Access Compliance Report

Public Rights-of-Way

(Pedestrian Signals)

Intersection ID: N/A	Main Street:	Cross Street: N/A	Location: N/A
ADA ID: C1E77AF51C2A	Signal Type: One Push Button-Non APS	Overall Compliance: No	Severity Score: BTN 1: N/A BTN 2: N/A No BTN: N/A
Codes/Mitigation Info/Possible Solution		Field Measurements/Component Compliance

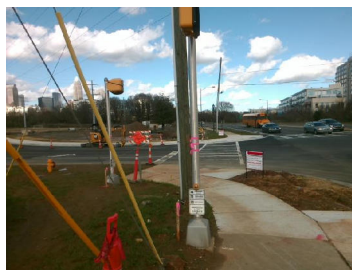
Yes B 1 Clear Xing Direction?	ClearlyMarked	N/A B 2 Clear Xing Direction?	N/A
B 1 Crossing Direction	To SE	B 2 Crossing Direction	N/A
Yes B 1 DistanceTo XWalk (in)	0.0	N/A B 2 DistanceTo XWalk (in)	N/A
No B 1 DistanceTo Curb (in)	181.0	N/A B 2 DistanceTo Curb (in)	N/A
Yes B 1 Diameter (in)	2.0	N/A B 2 Diameter (in)	N/A

Possible Solutions: Replace Signal Push Button With APS Button on New Post. Remove & Relocate Sign.
